RE: TRANSPORTATION UPDATE LETTER
FILE NO. A05/20 OPA 20-001/P D-5100
2055 BROCK ROAD
CITY OF PICKERING, DURHAM REGION

The Transportation Update Letter herein, accompanies the previously submitted TIS Addendum, dated September 2021, summarizes the changes in the most recent Site Plan, as well as addresses the City's most recent comments.

Comment Response Matrix

Vehicle Turning Diagrams

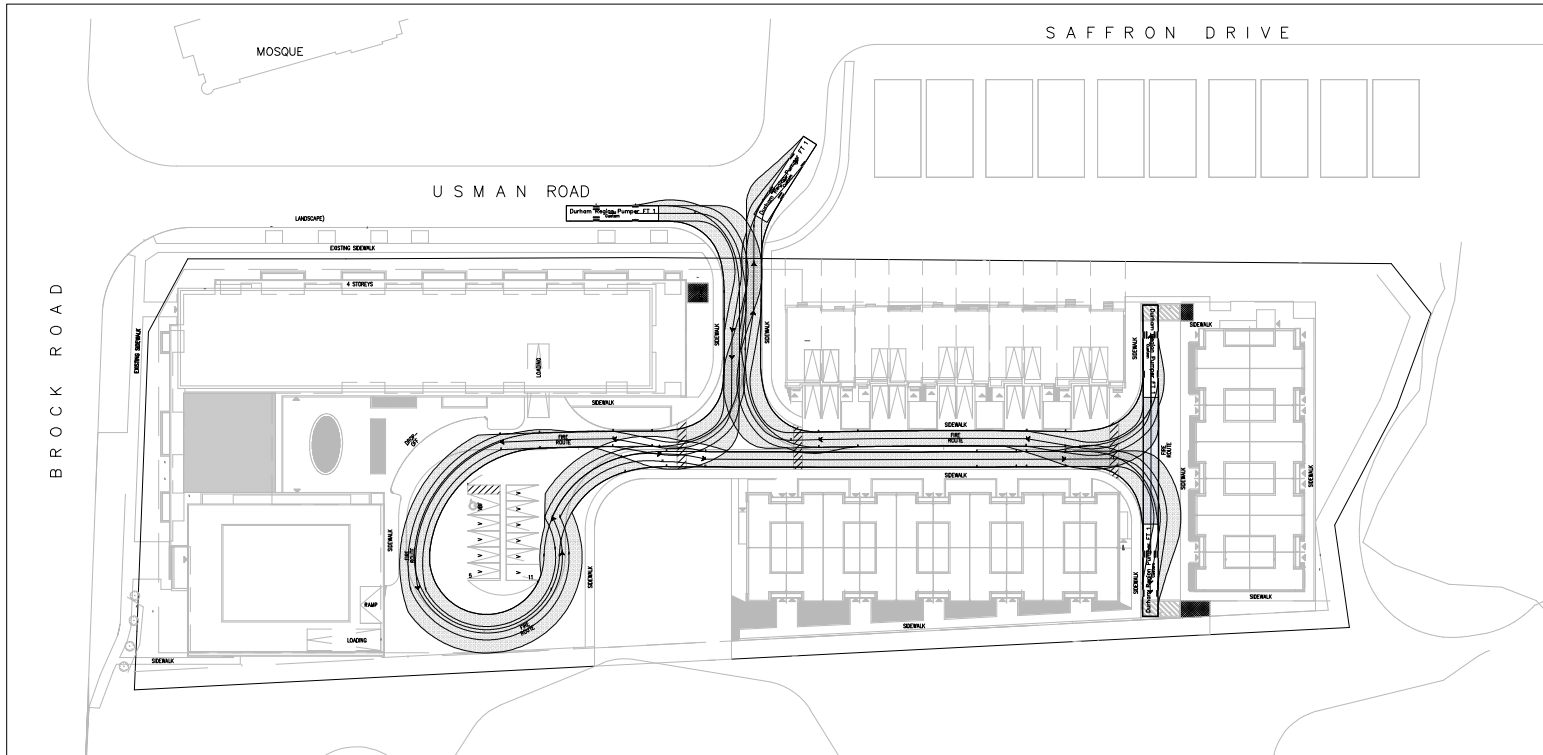
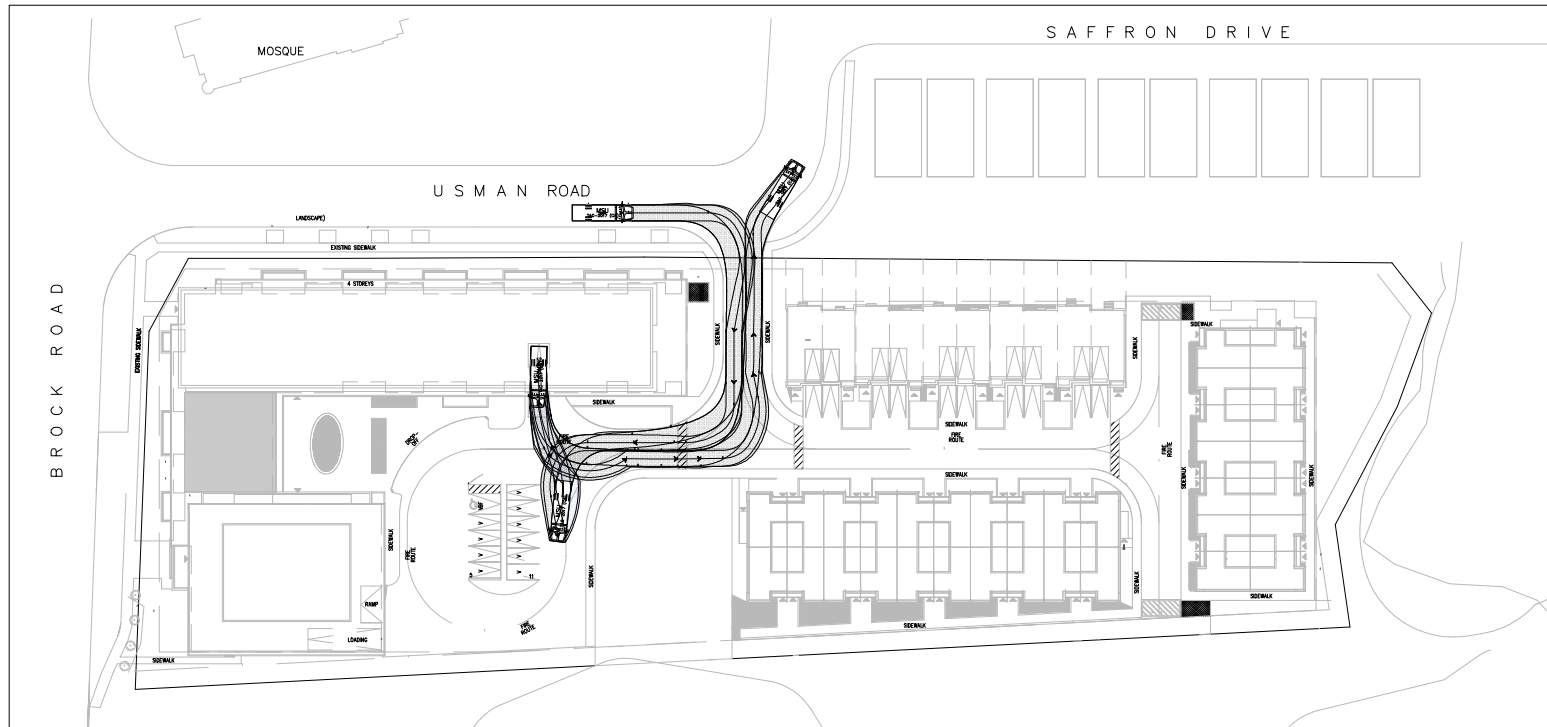
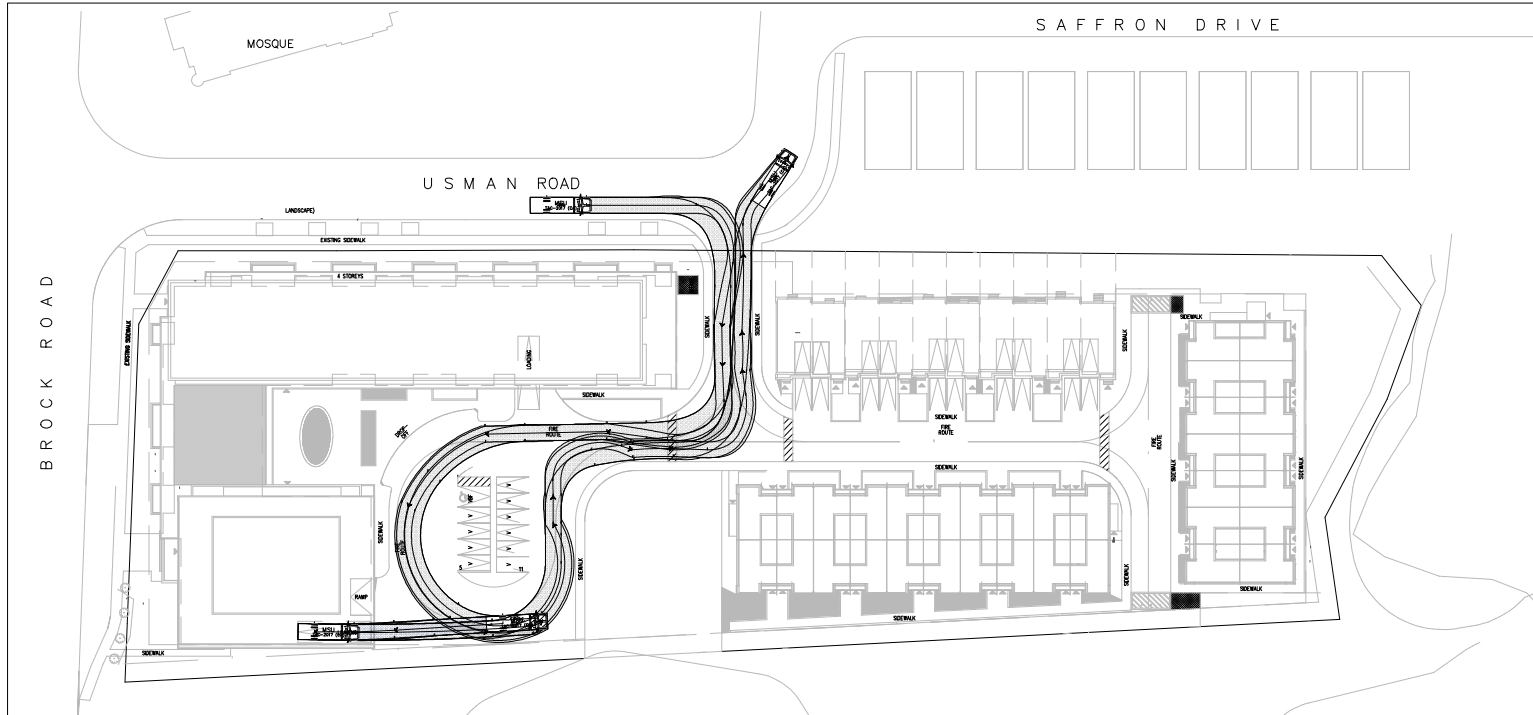
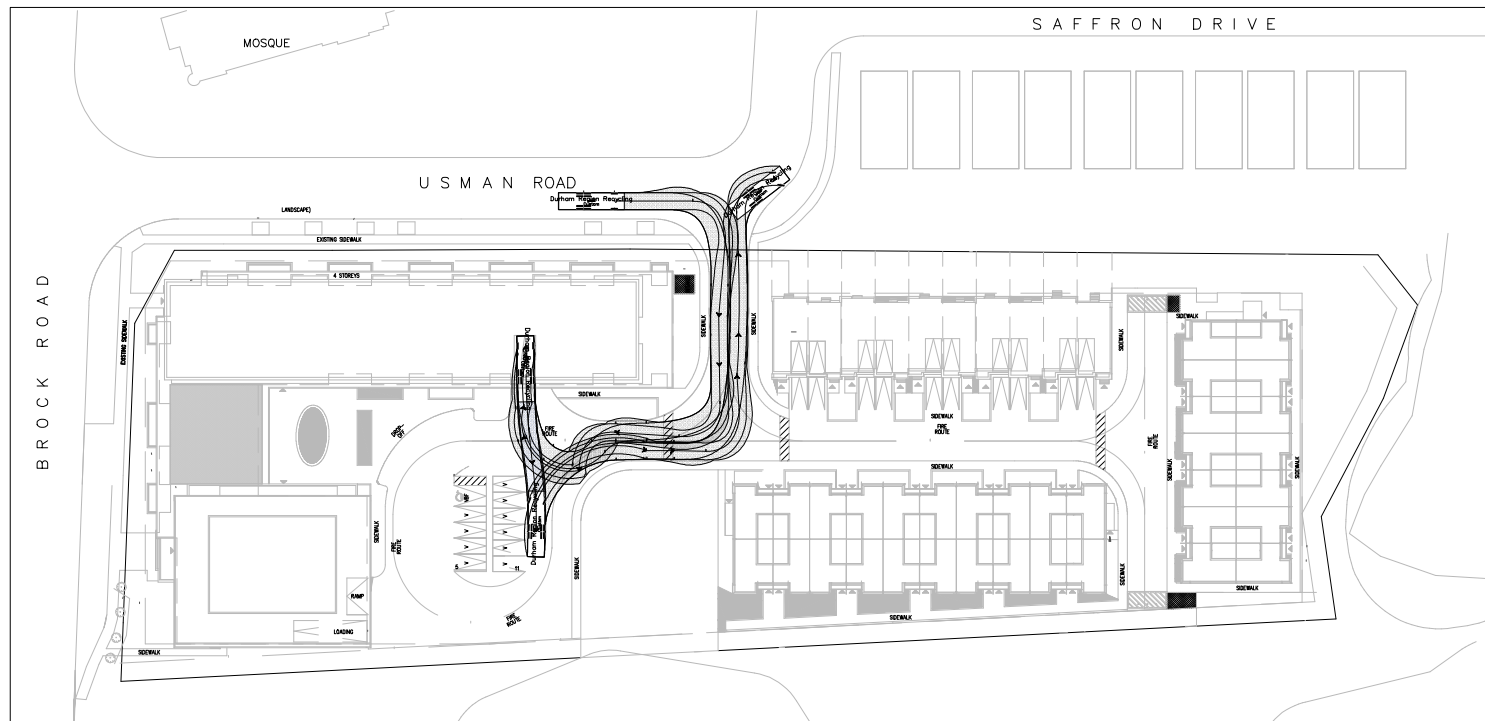
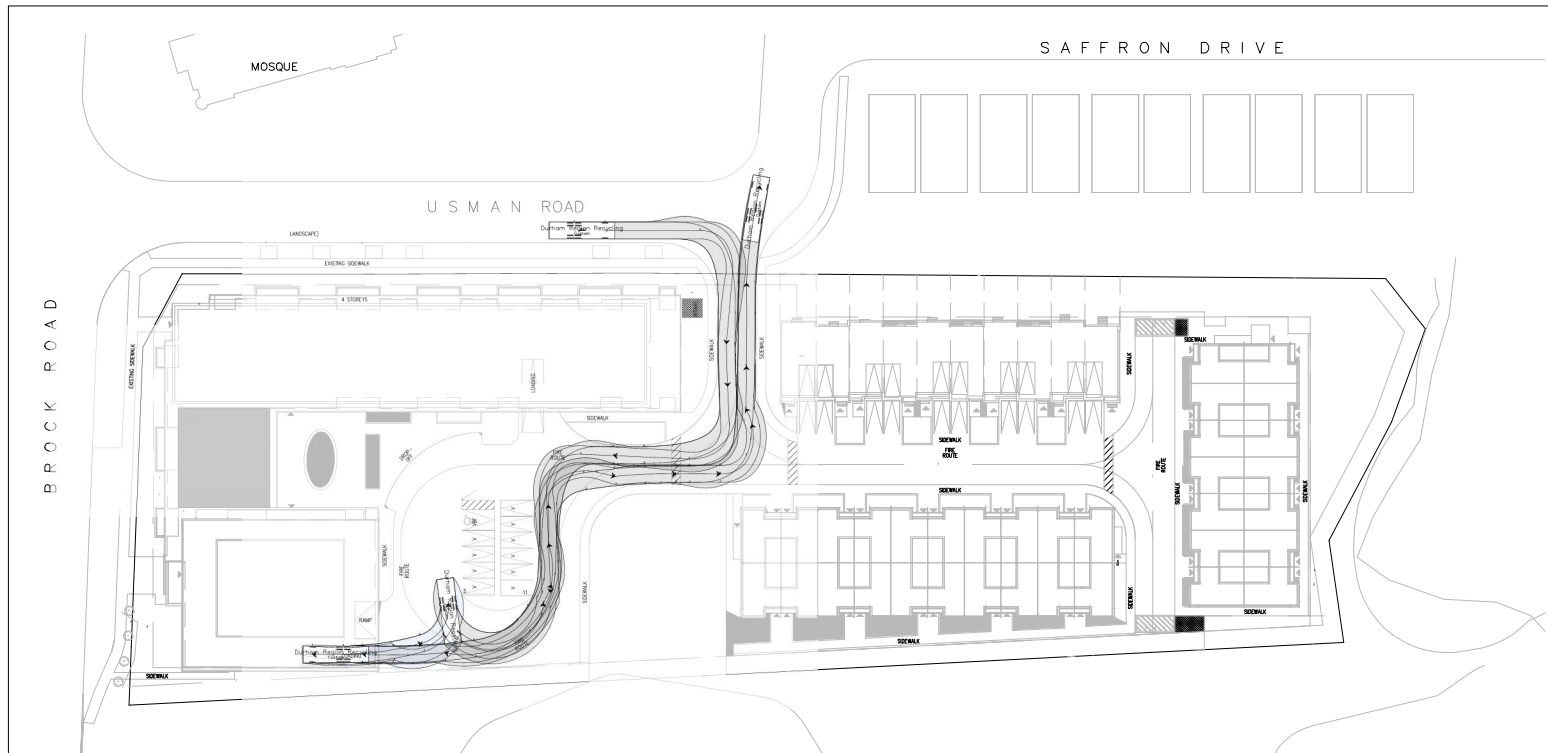
| Department/Agency | Comment | Crozier Response |
|--|---|---|
| | Provide an Autoturn diagram for all the proposed design vehicles including a fire truck. | Vehicle Turning Diagrams were previously provided as part of the TIS. Nevertheless, updated Vehicle Turning Diagrams were prepared per the latest Site Plan. The Vehicle Turning Diagrams are included as Attachment 4 . |

As required by Durham Region Waste Management Services, a 13-metre centerline radius has been provided along the drive aisle, where waste collection vehicles are expected. Per discussion with the proponent, waste collection for the development will exclusively take place at the Block A loading spaces.

Based on the updated Vehicle Turning Diagrams, no operational issues are expected for waste collection vehicles, delivery vehicles (i.e., MSU), and fire trucks.

Trip Distribution & Assignment Figures

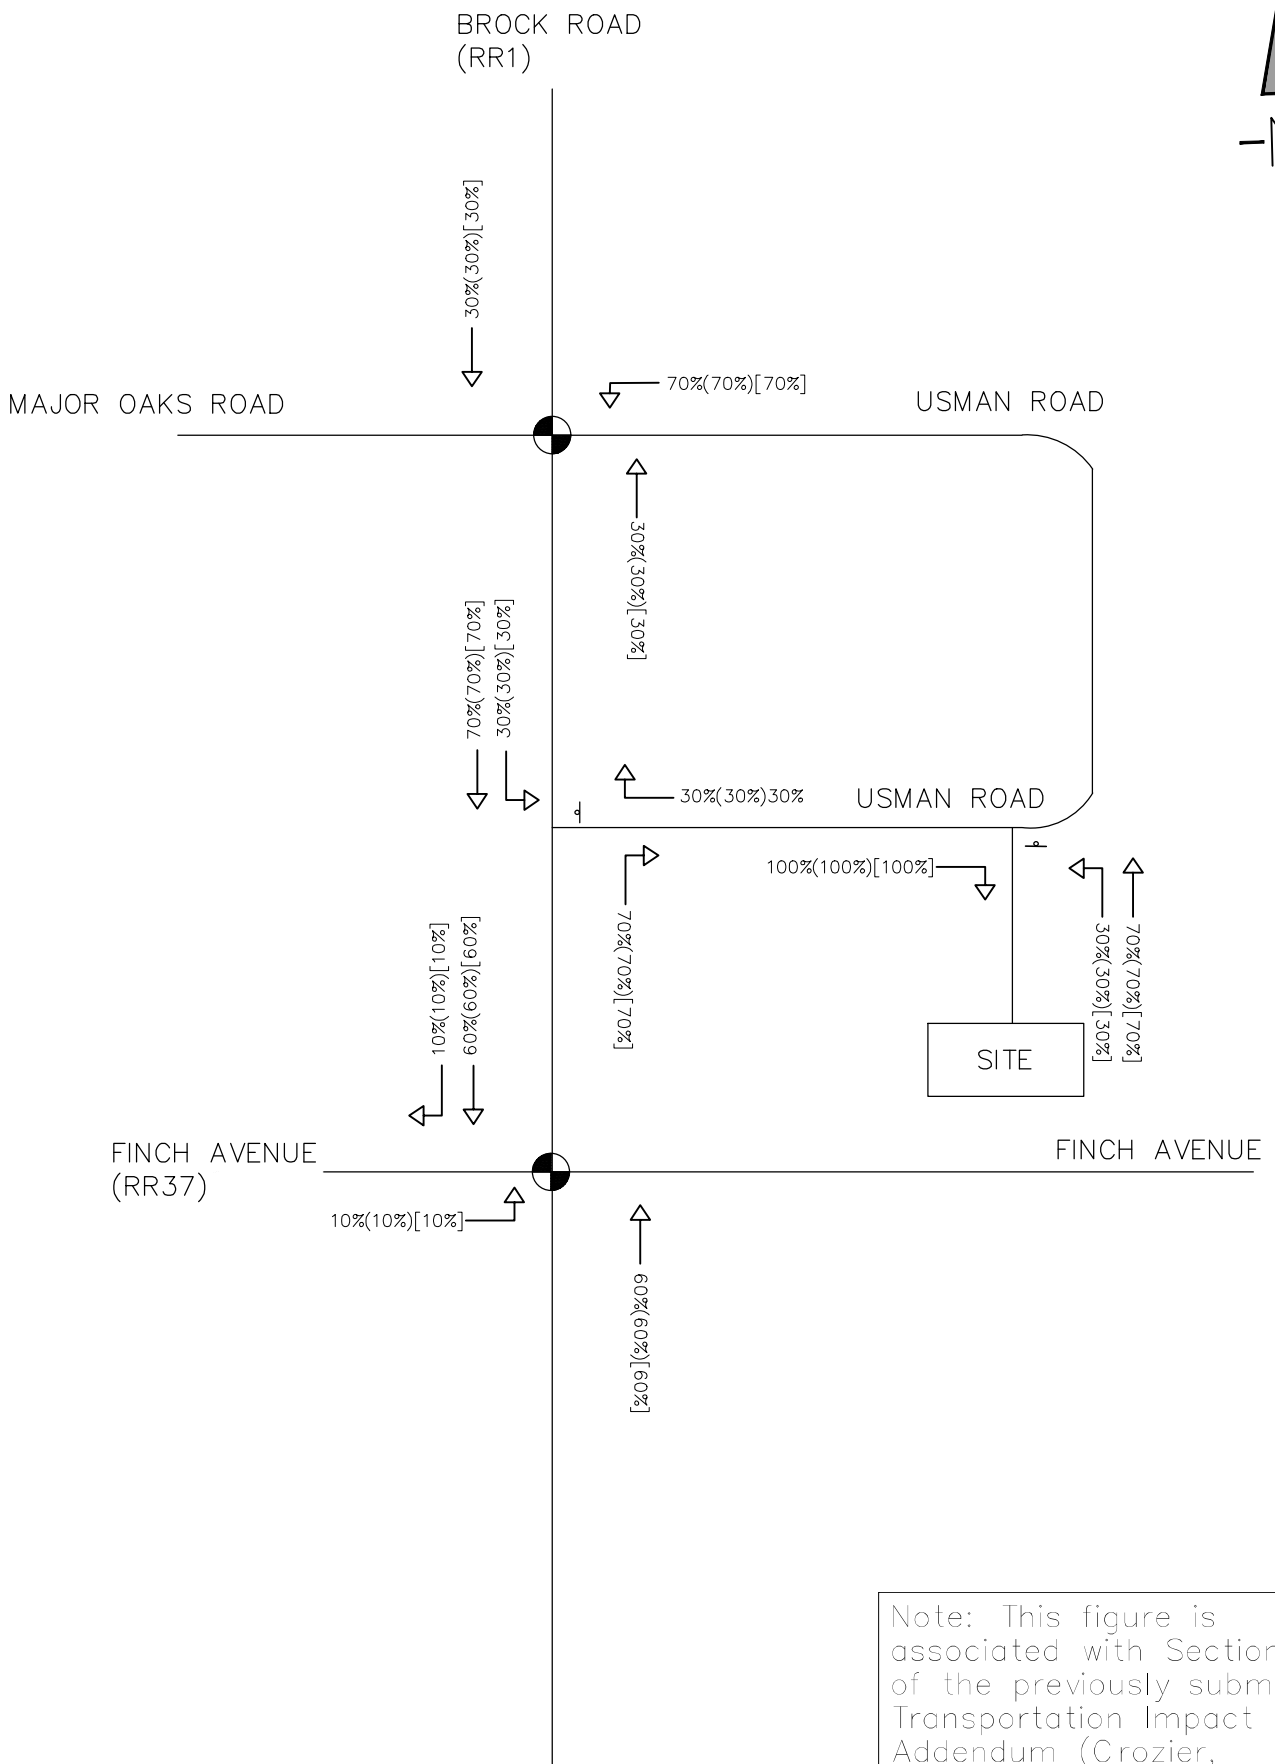
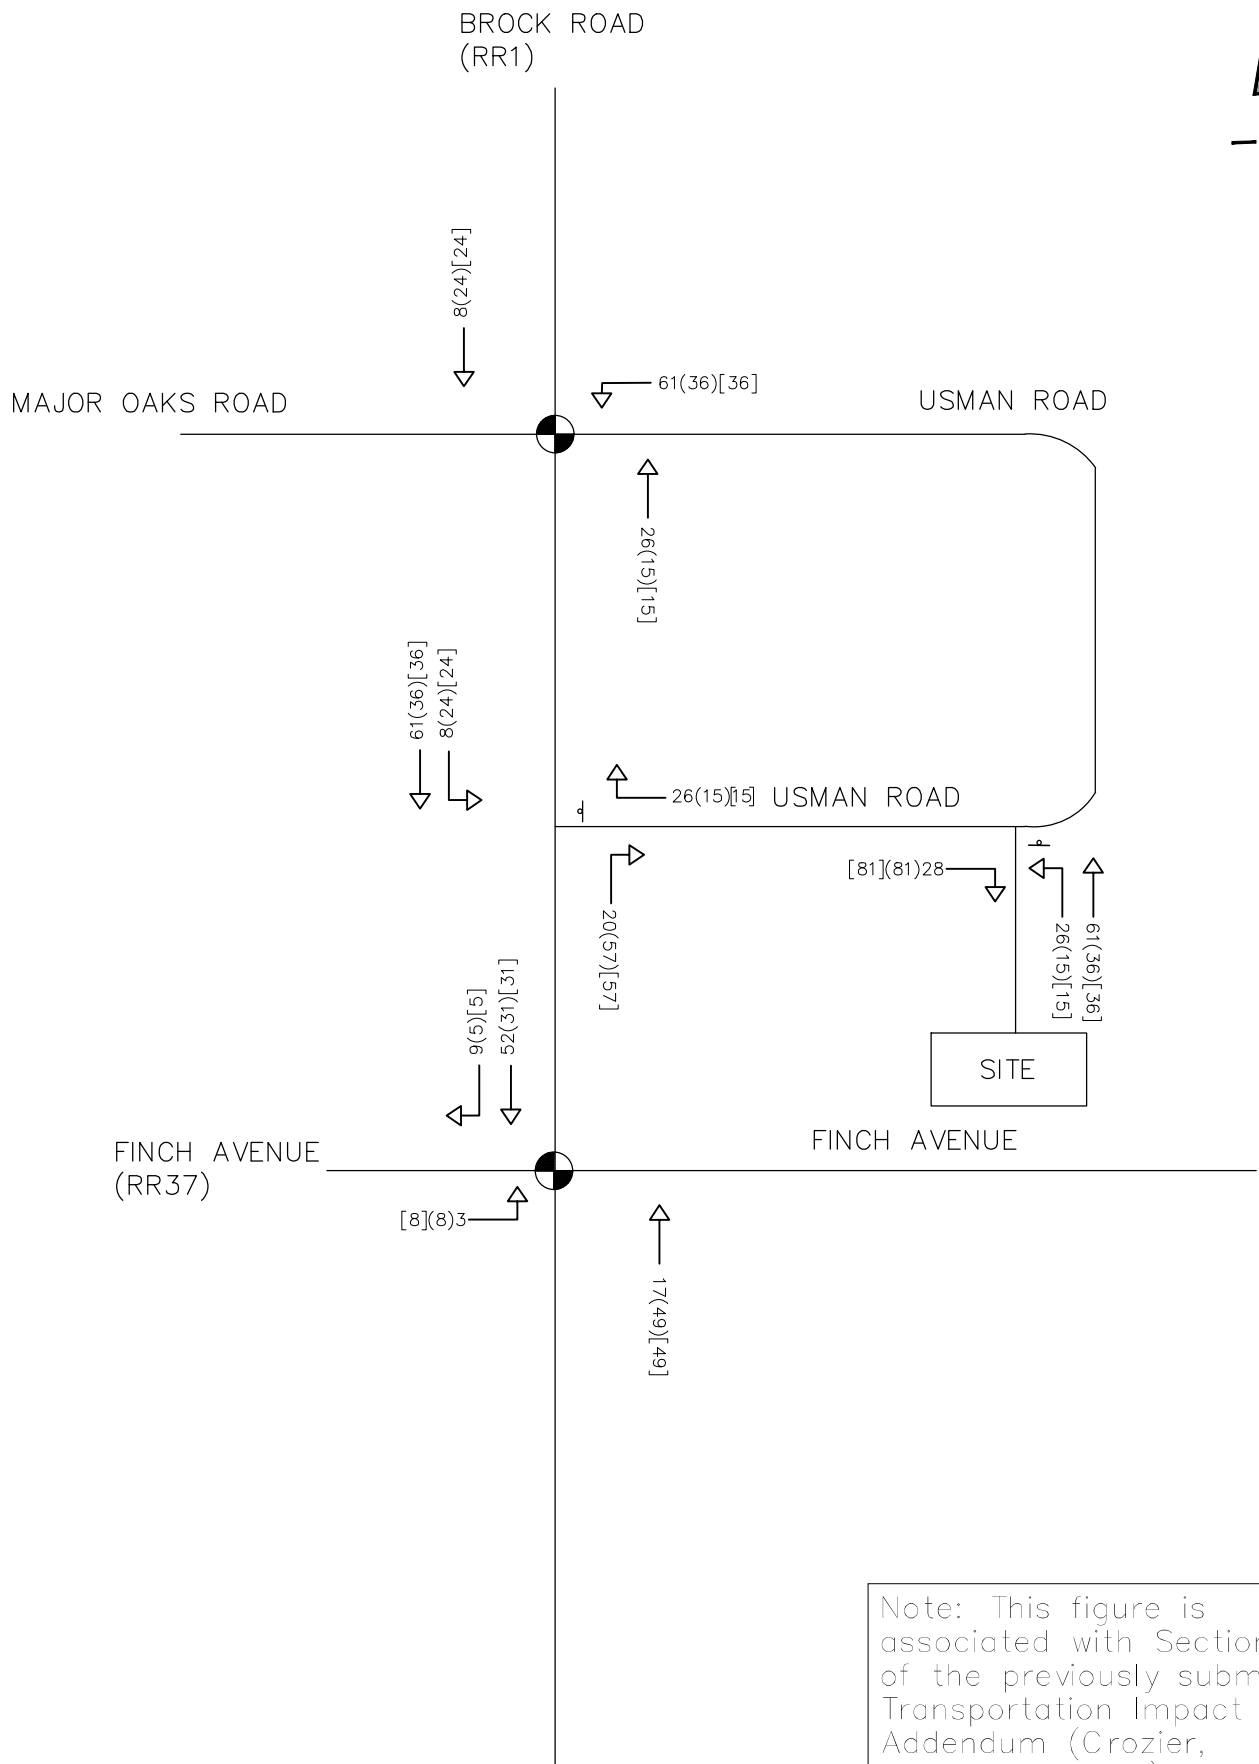
Per City staff request, the previous Trip Distribution and Assignment traffic volume figures have been included as **Attachment 5**. It is noted that these figures are associated with the base trip assignment reviewed in **Section 5.0** of the previously submitted TIS Addendum (Crozier, September 2021).
